ADDENDUM #2

Project Name:
Newton Correctional IPI Homes for Iowa Phase II - Fencing
DAS Project # 9239.04
RFB 923904-01
Addendum #2
Dated: June 16, 2026

1 TYPICAL PERIMETER FENCE SECTION
SCALE: 1/2" = 1'-0"

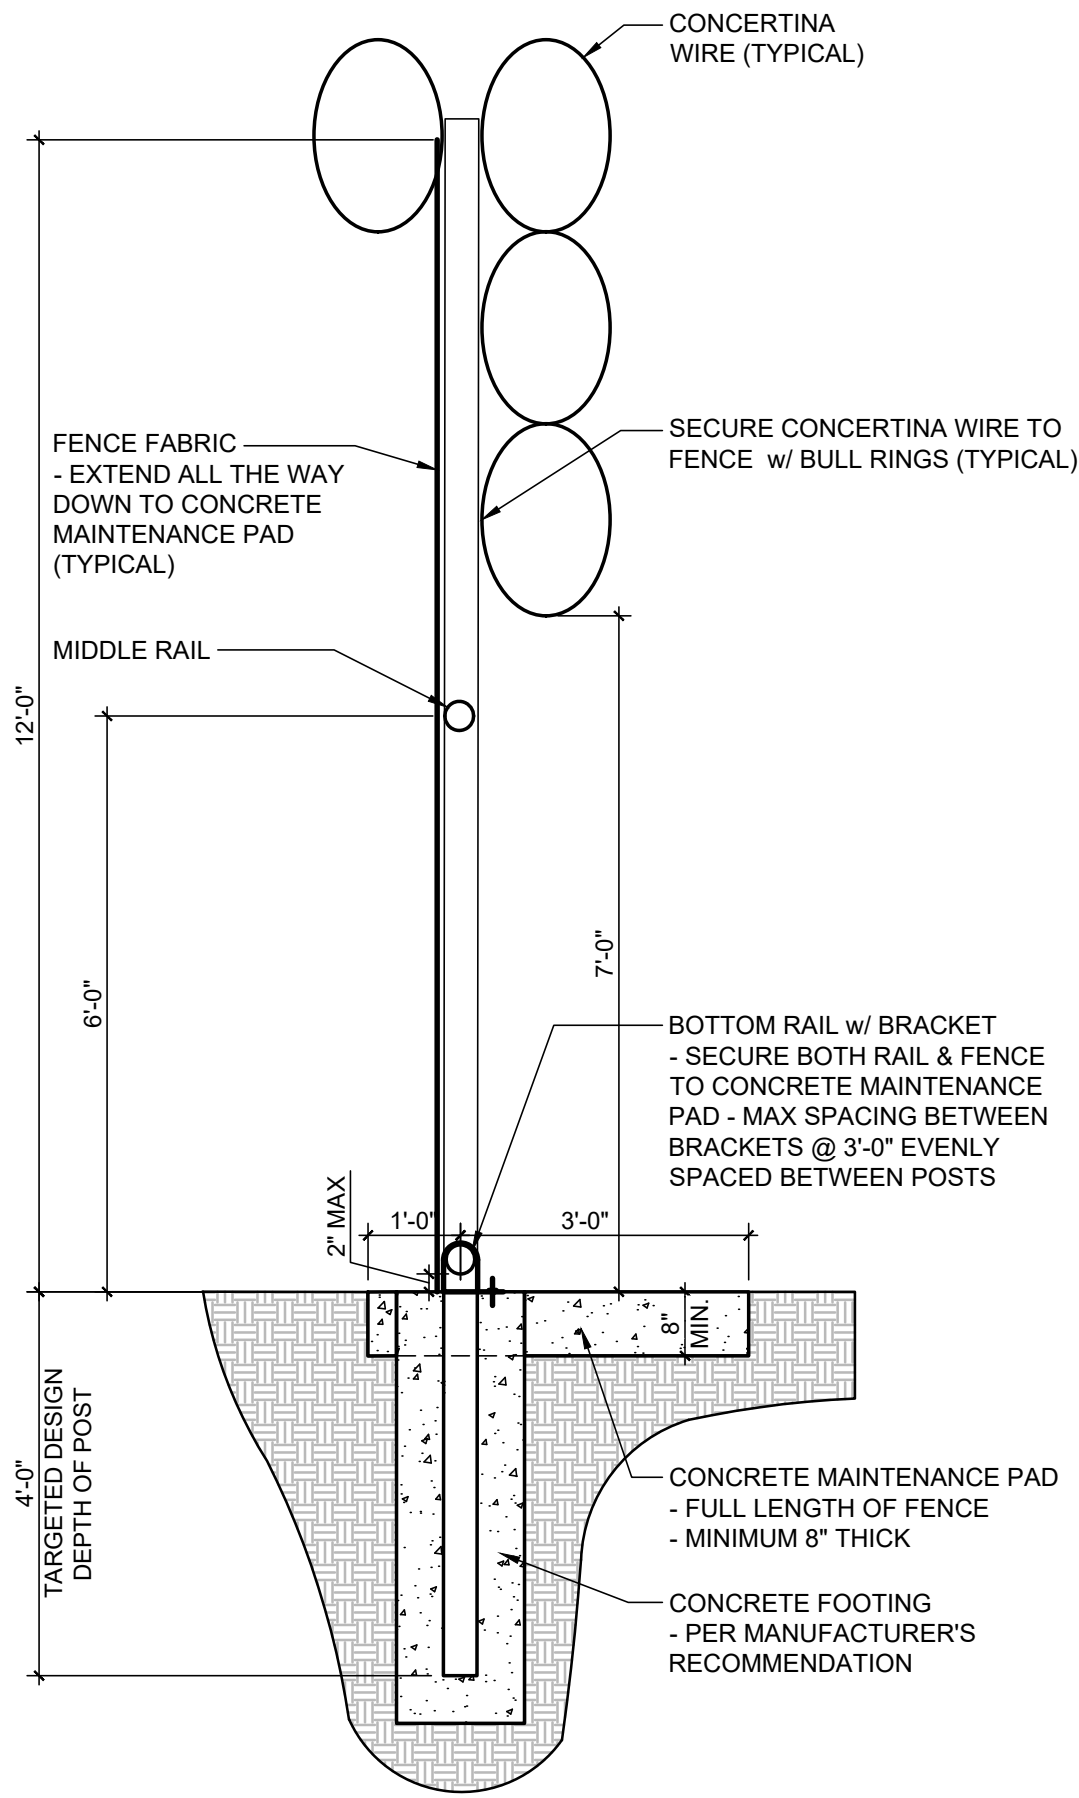
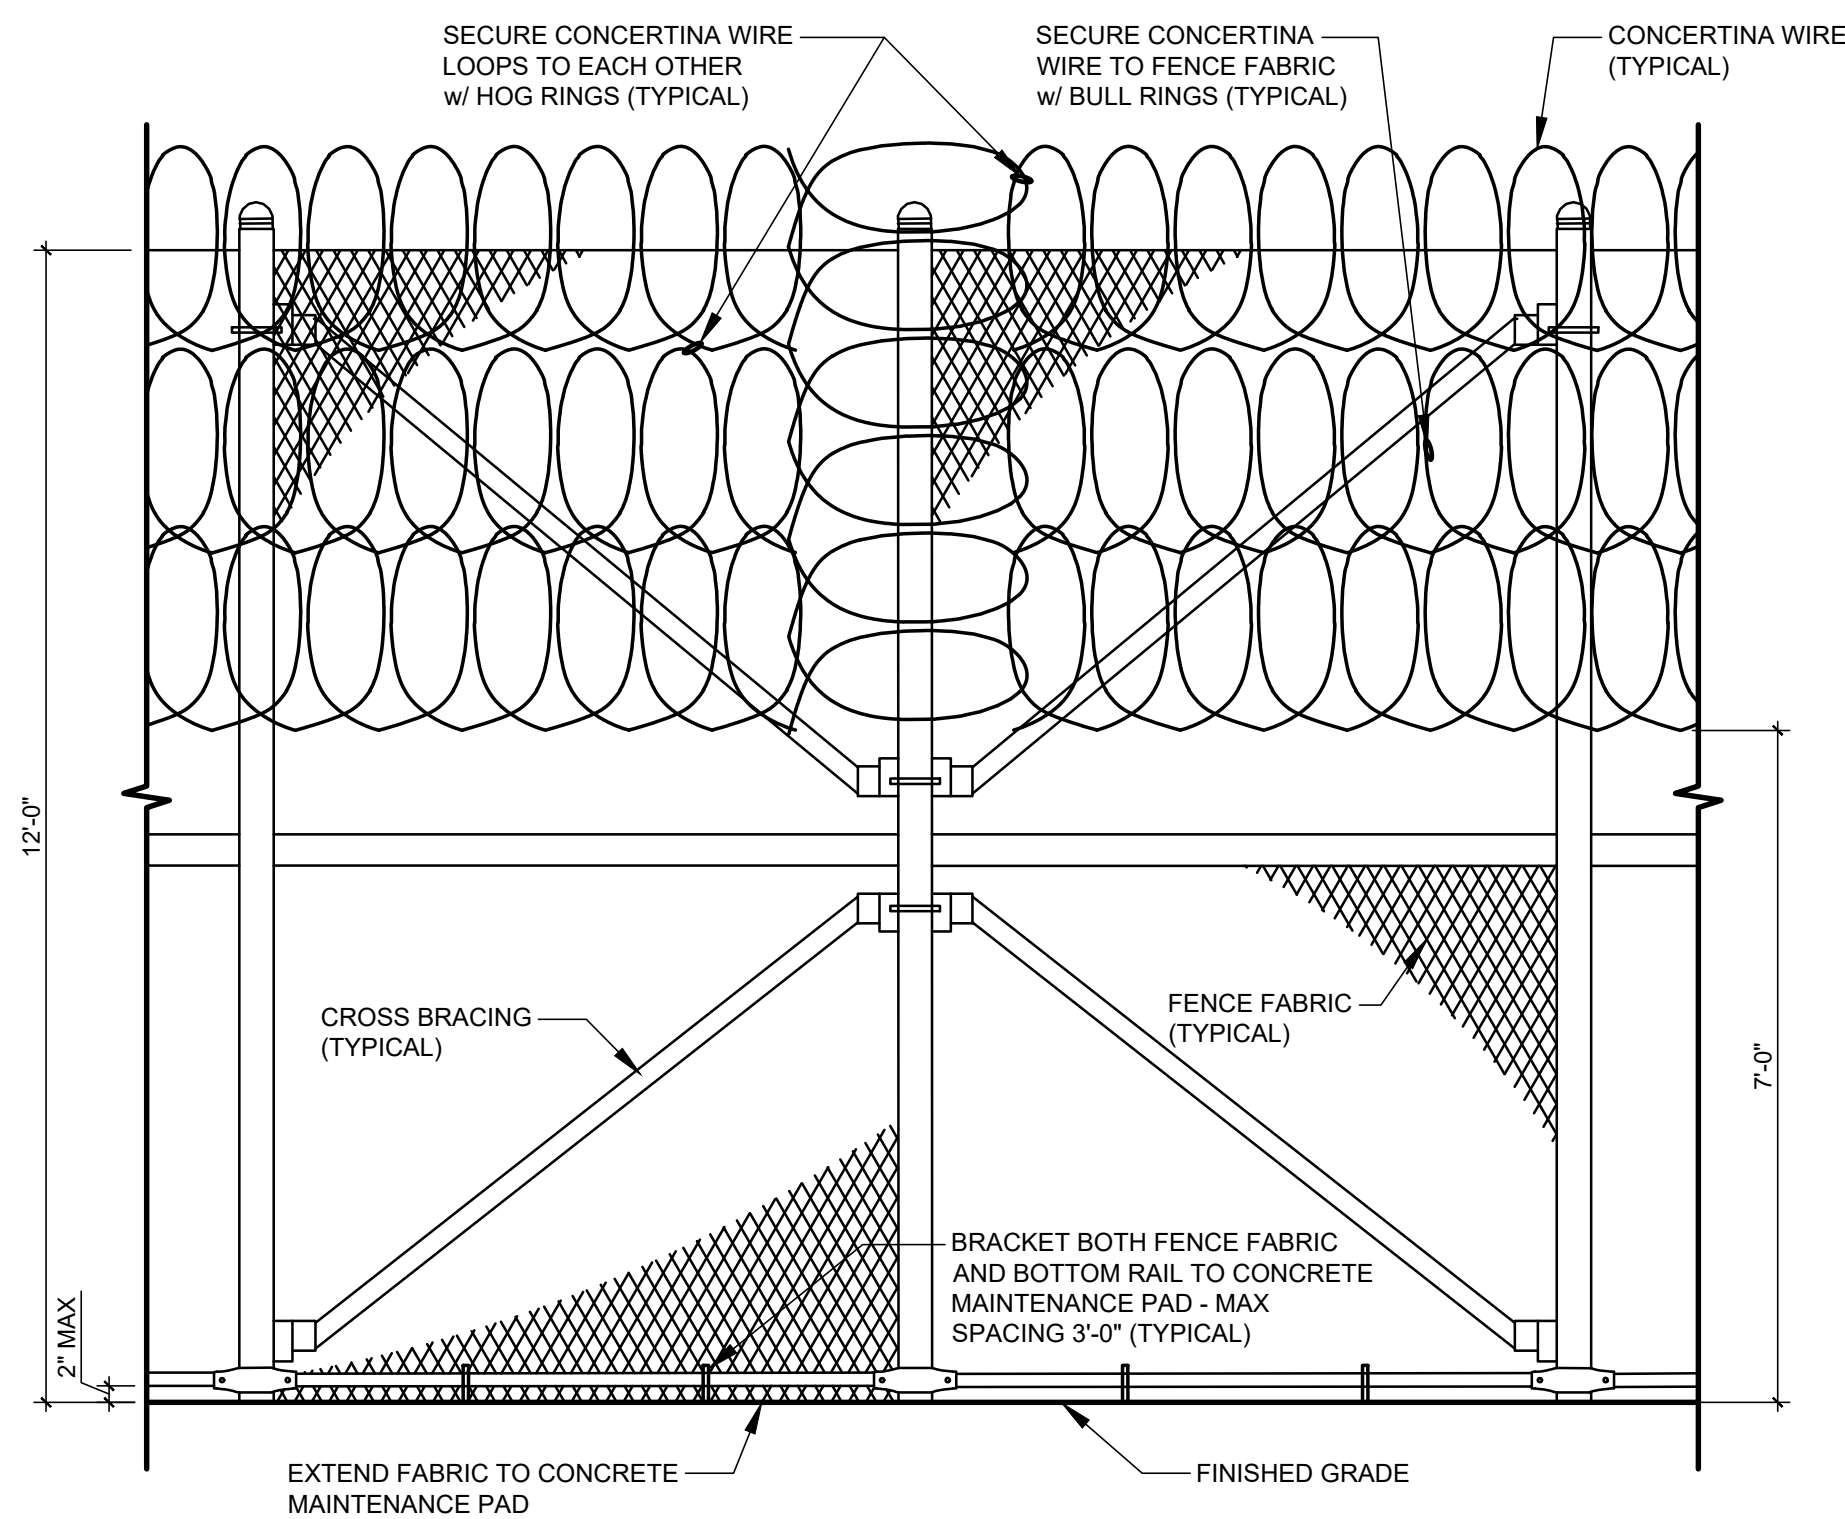
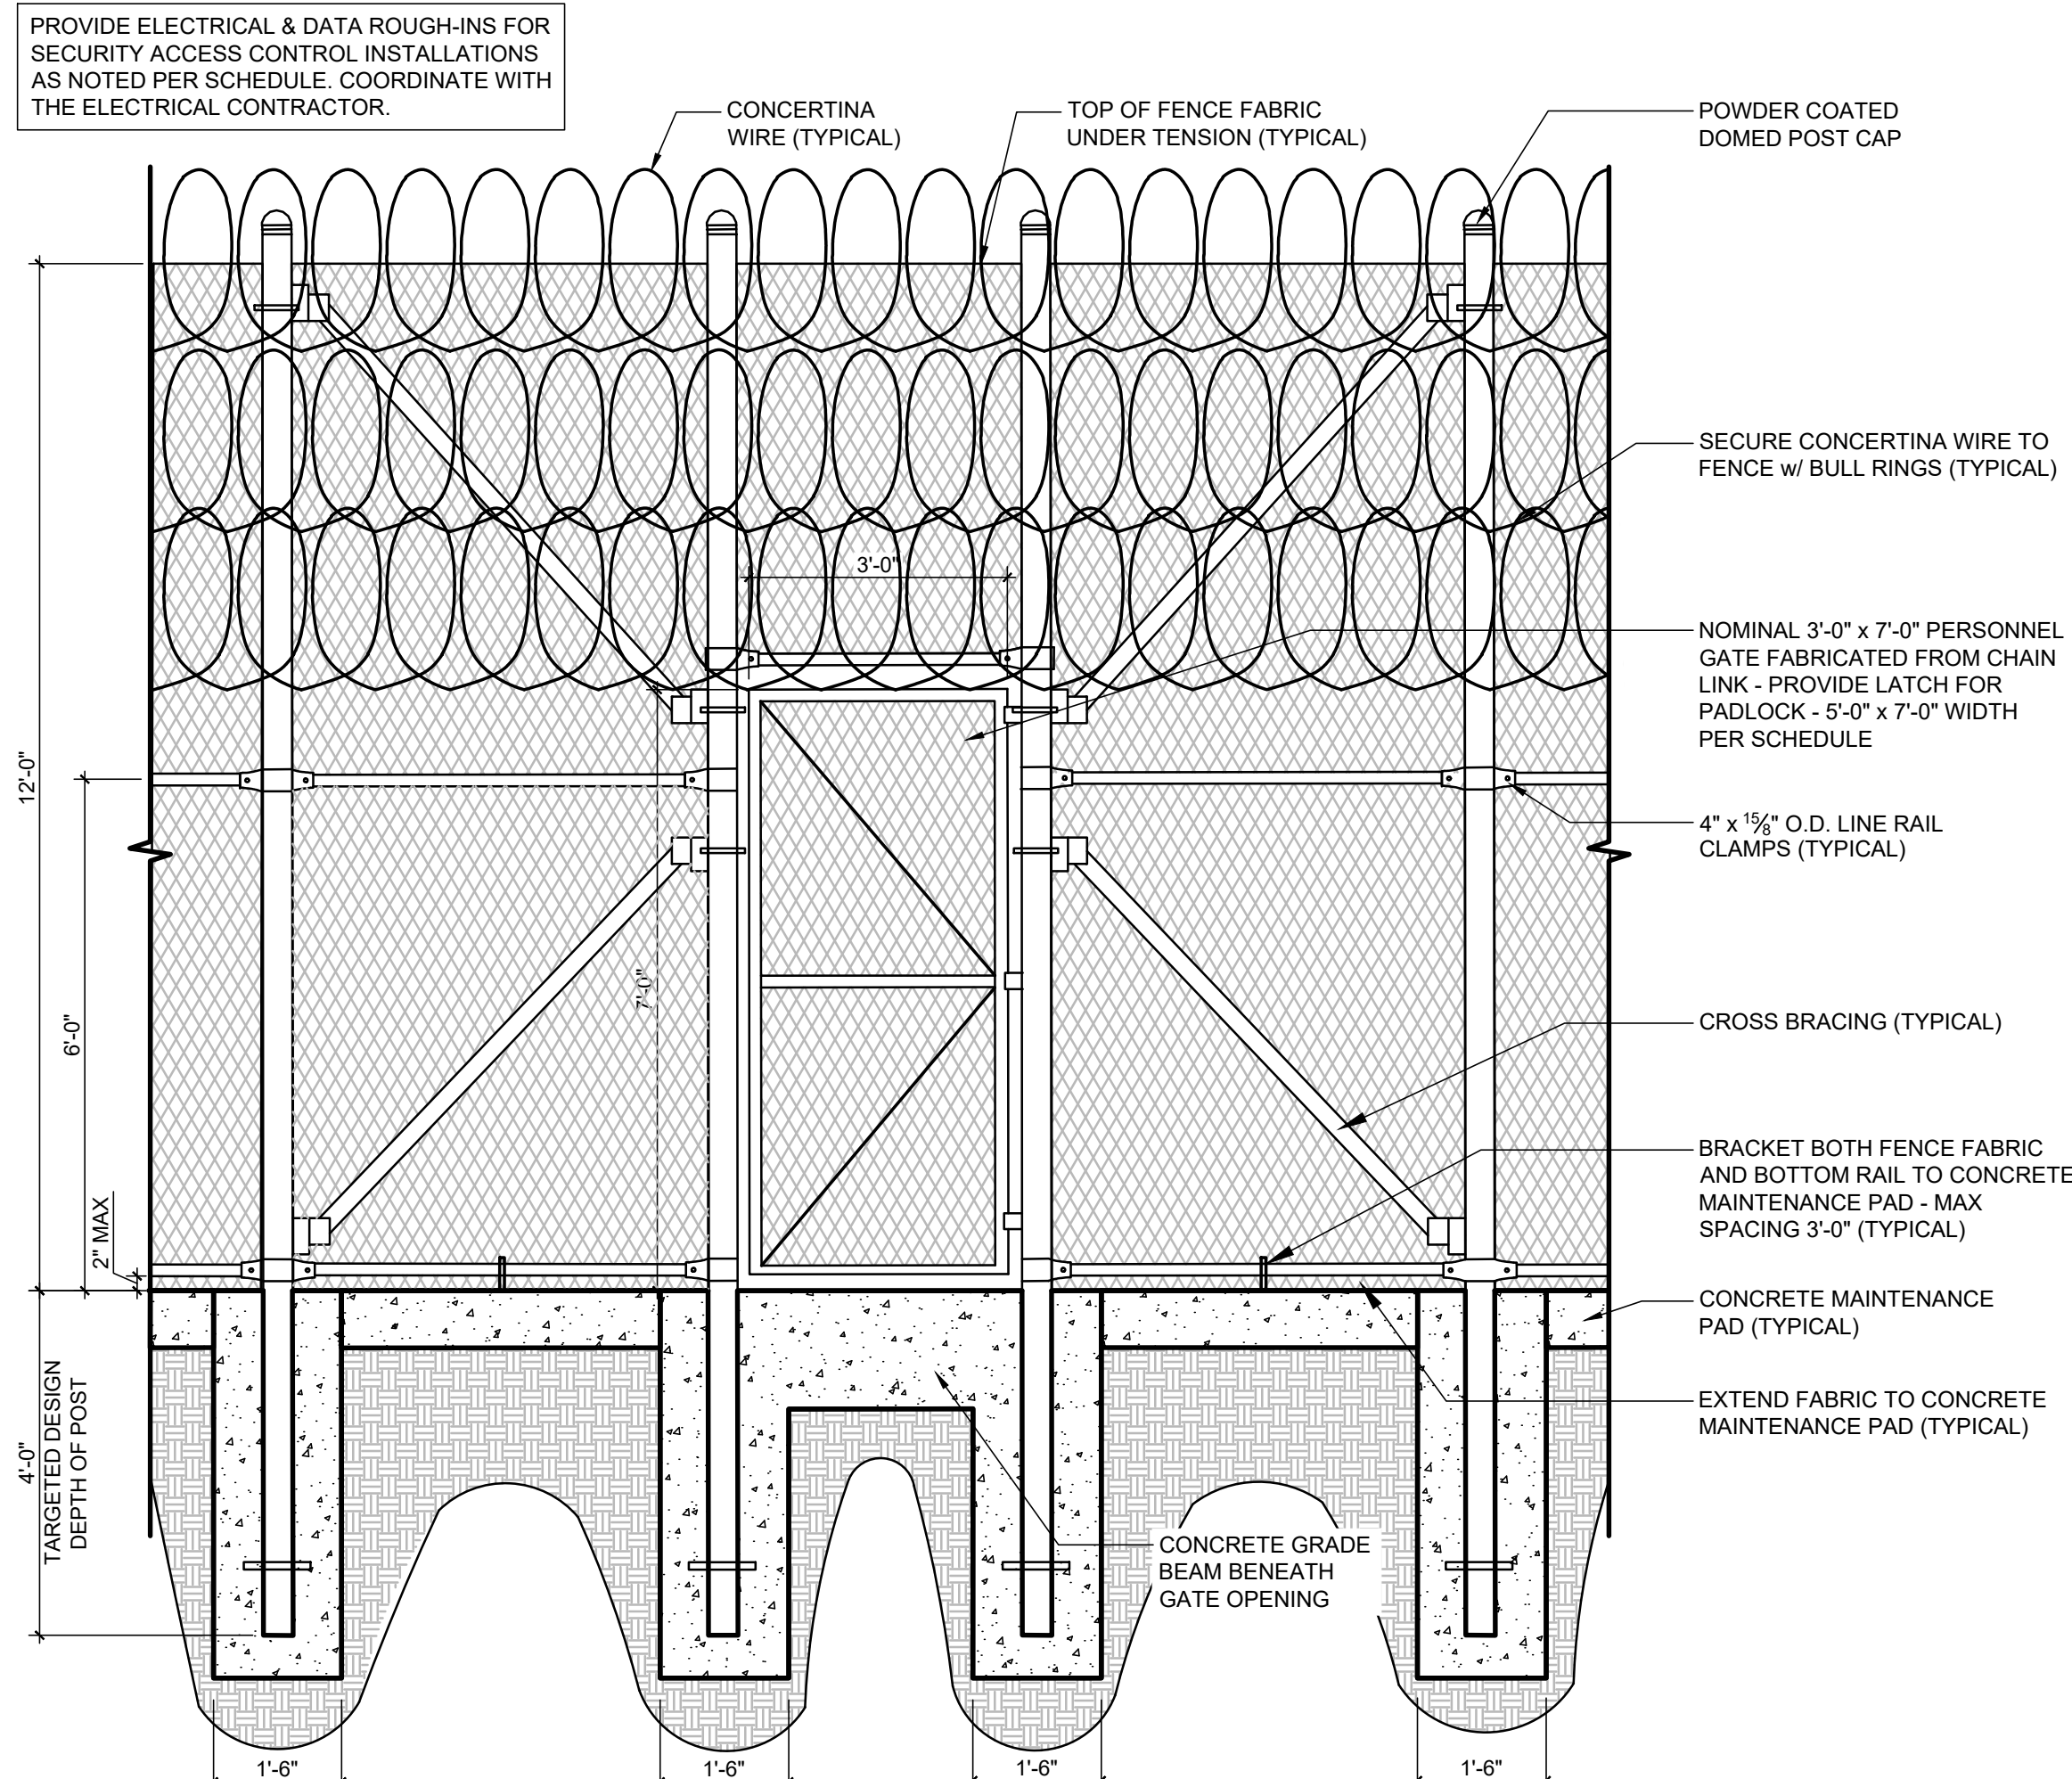
- Item No. 16 REPLACE drawing sheet in its entirety.
All details have been modified.
SECURITY FENCE NOTES have been added for additional reference.
